APP-GW-GLN-116-NS, Revision 0

“Additional Liquid Radwaste Monitor Tanks and Radwaste Building Extension”

Technical Report 116

**Document Number:** APP-GW-GLN-116 **Revision Number:** 0

**Figure 116-2 Radwaste Building Room Numbering**

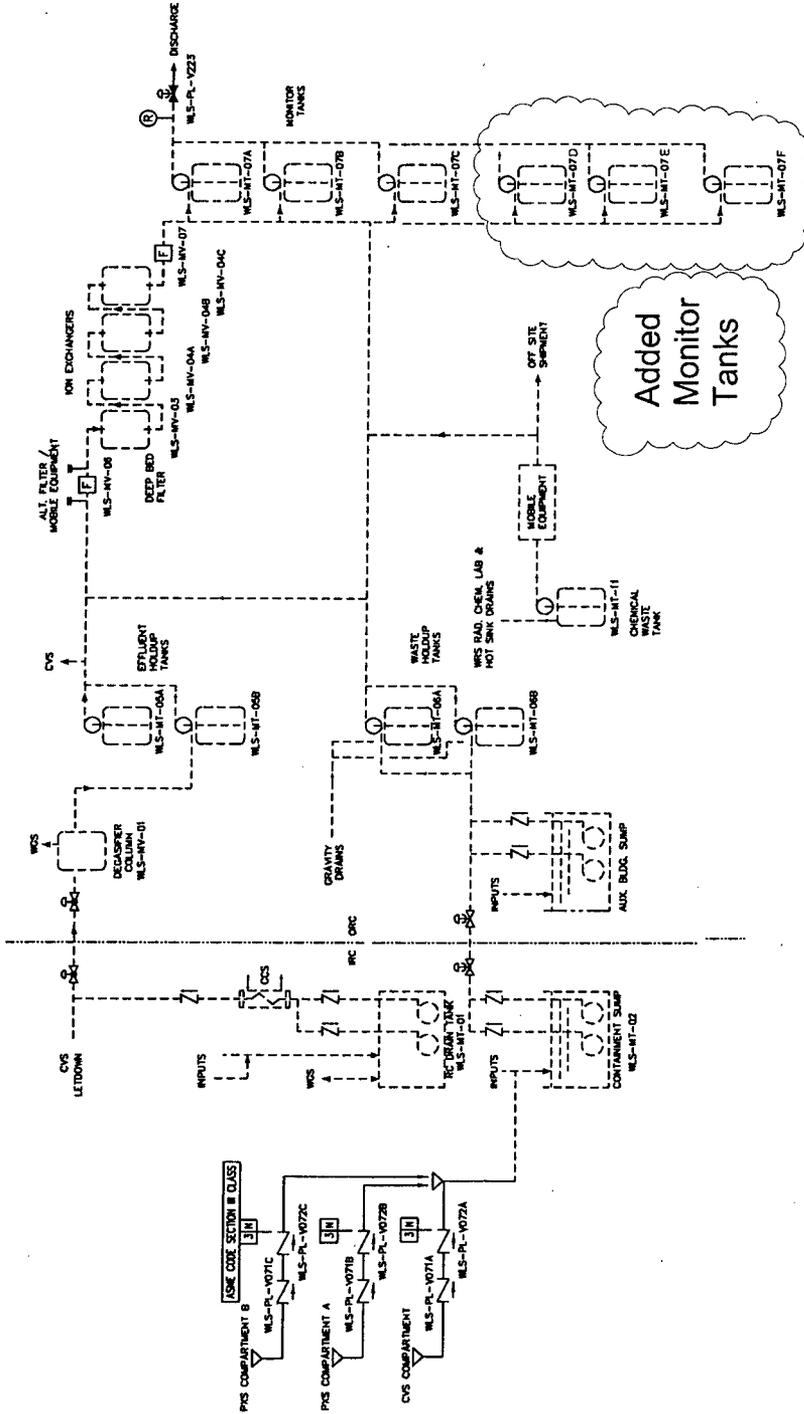
The revised radwaste building room numbering is as shown in Figure 116-2.
